ADDENDUM # 11

WEGO Transit and Fleet Operations Center Expansion

Request for Proposal No: RFP-22-2024-AD
Issue Date of Addendum: January 17, 2025
Proposal Submission Deadline: January 24, 2025 at 2:00 p.m. ET

ADDENDUM No.3

Interior Screen @ Office A

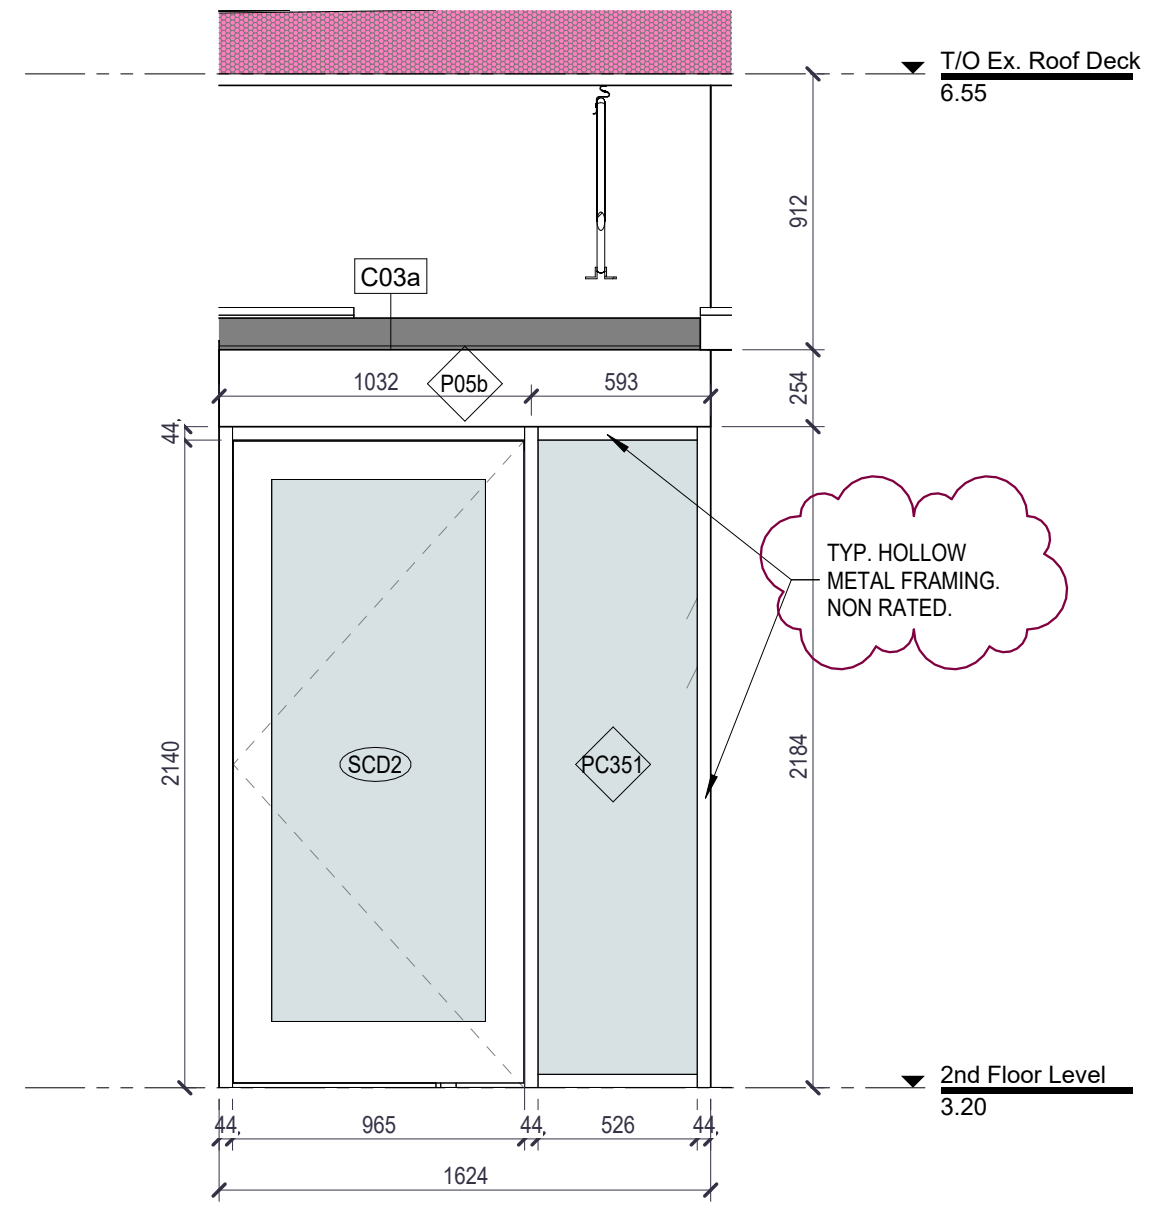
14. Further to addenda # 9 item 3..... " I just read addendum 9 and the response in regard to SC1. The architect describes this as a fire rated screen (an aluminum frame and fire rated glass, 60 minutes of protection required)

15. Please confirm what type of fire rated aluminum frame is required. Typically these screens are specified as hollow metal for economy. Aluminum clad steel fire rated frames are very expensive.

ANSWER: Hollow metal frames are specified, per Raimondo addendum 2.

ANSWER: Hollow metal frames are specified, per Raimondo addendum 2.

* = FIRELITE FIRE RATED GLASS, MIN. 60 MINS.
GC TO COORDINATE SHOP DRAWINGS
FOR REVIEW AND COORDINATION.
